TECHNICAL BULLETIN

[Issue No.] GOT-A-0179

[Title] Changing the LCD (Display Device) of the GT2506HS-VTBD

[Relevant Models] GOT2000 Series (GT2506HS-VTBD)

2. Details of the change

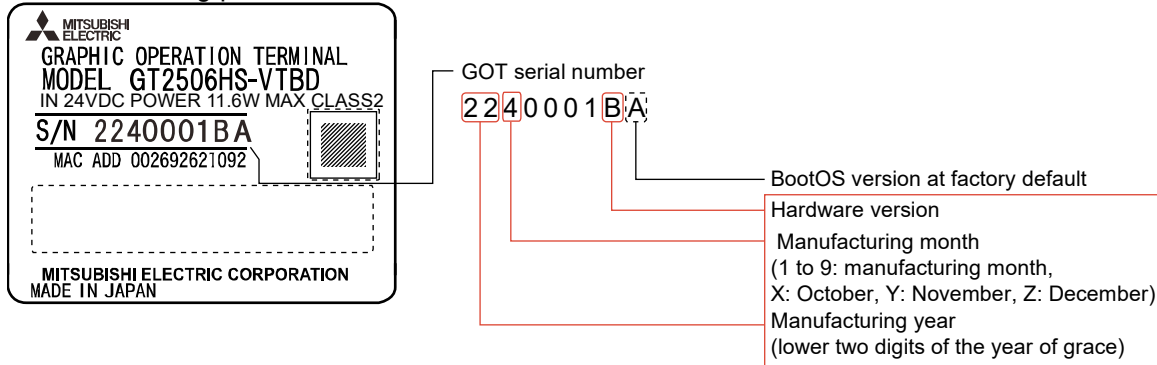
Thank you for your continued support of Mitsubishi Electric Graphic Operation Terminal (GOT). This bulletin informs you that the LCD (display device) of this GOT2000 series model will be changed. The change does not affect the general specifications, product specifications, functions, and external dimensions of the product.

However, colors on the LCD and display characteristics may be slightly different.

The LCD (display device) will be changed.
